Access Compliance Report

Public Rights-of-Way

Intersection ID: 42578	Main Street: PEACEFUL_WAY_DR	Cross Street: STROUD_PARK_CT	Location: SE
ADA ID: 23BC87AD852A	Ramp Type: PerpDiag	Initial Pass/Fail: Fail	Overall Compliance: No
		Severity Score: 17.5

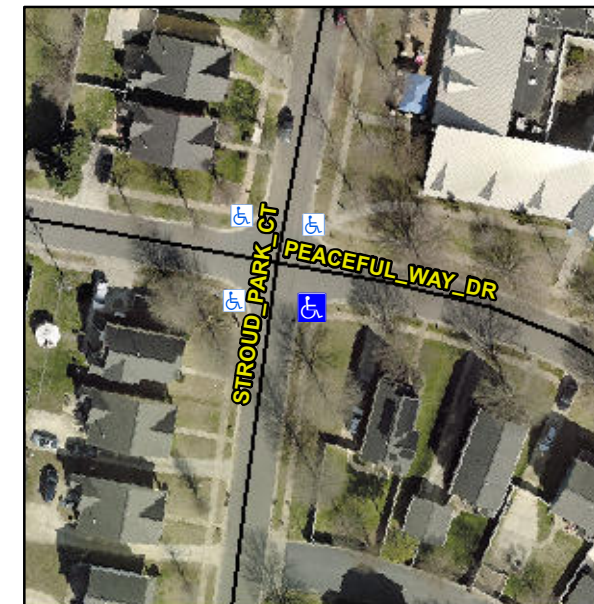
Not Found, R304.5.1

Compliance	Description	Data	Compliance	Description	Data
N/A	Ramp Length (in)	47.0	Yes	Ramp Slope (%)	5.2
No	Ramp Width (in)	35.5	Yes	Ramp XSlope (%)	0.3
N/A	Flare Type LT	N/A	N/A	Flare Type RT	N/A
N/A	Flare Slope LT (%)	N/A	N/A	Flare Slope RT (%)	N/A
N/A	Flare Traversable LT?	N/A	N/A	Flare Traversable RT?	N/A
N/A	Landing Length (in)	N/A	N/A	DWS Provided?	N/A
N/A	Landing Width (in)	N/A	N/A	DWS Contrast?	N/A
N/A	Landing Slope (%)	N/A	N/A	DWS Length (in)	N/A
N/A	Landing X Slope (%)	N/A	N/A	DWS Full Width?	N/A
N/A	Landing Curb? (Y/N)	N/A	N/A	DWS Offset (in)	N/A
N/A	Shared Landing?	N/A			
N/A	Gutter Ponding?	N/A	N/A	Gutter Slope (%)	N/A
N/A	Gutter Lip Ht (in)	N/A	N/A	Gutter X Slope (%)	N/A
N/A	Painted X Walk1?	No	N/A	Painted X Walk2?	No
	X Walk 1 Direction	To N		X Walk 2 Direction	To NW
N/A	X Walk 1 Width (in)	N/A	N/A	X Walk 2 Width (in)	N/A
	X Walk 1 Slope (%)	3.0		X Walk 2 Slope (%)	4.8
	X Walk 1 X Slope (%)	0.4		X Walk 2 X Slope (%)	0.8

Remove & Replace Curb Ramp With Two New Directional Ramps or Equivalent.
